January 31, 2022

Subject: Comments regarding continuous monitoring provisions in the Proposed New Source Performance Standards and Emissions Guidelines for Control of GHG Emissions from the Oil and Natural Gas Sector, Docket ID No. EPA-HQOAR-2021-0317

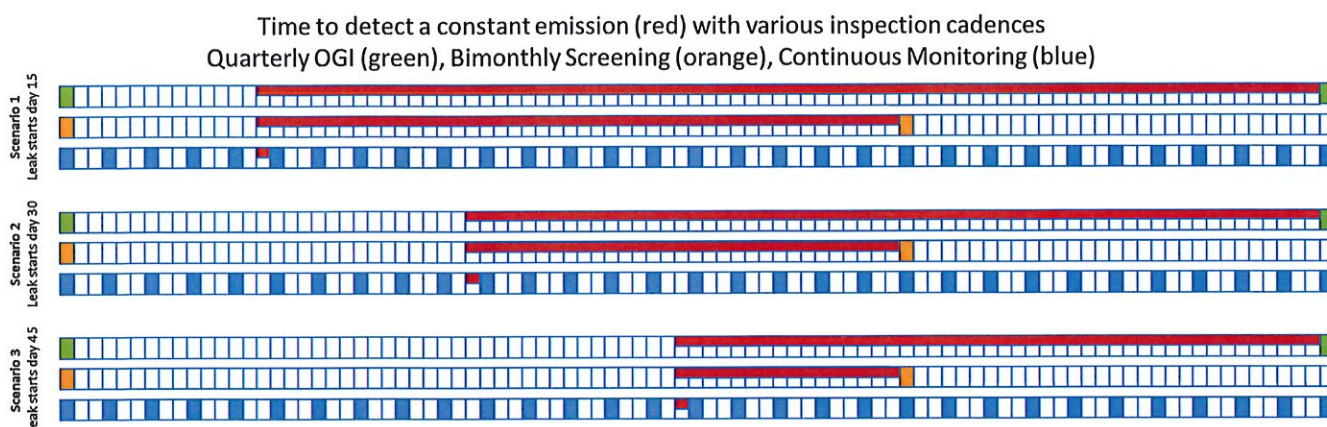
Time to detection is, perhaps, the most critical of these benefits. In concept, as few as one sensor may be acceptable in a region where a monitor can be placed downwind of the facility in the direction of the prevailing wind, provided that is the prevailing wind on a continual basis. Often, there is seasonal variation in prevailing wind direction which should be accounted for in the number of sensors specified for a particular location. Wind analysis can inform where to site a small number of monitors to offer adequate coverage. This should be addressed in a site-specific monitoring plan.

Additional sensors for the ability to discriminate offsite sources and triangulate sources within the facility should be optional since these may aid an operator in identification, but the consequence of not having them is a simply a higher burden of analysis for the operator.

An important feature that should be addressed within a monitoring plan is the proximity of monitors to the nearest source. We recommend that monitors be no closer than one and a half times the height of the nearest source to allow adequate dispersion for detection. We recommend the detection point be no lower than six feet from the ground.
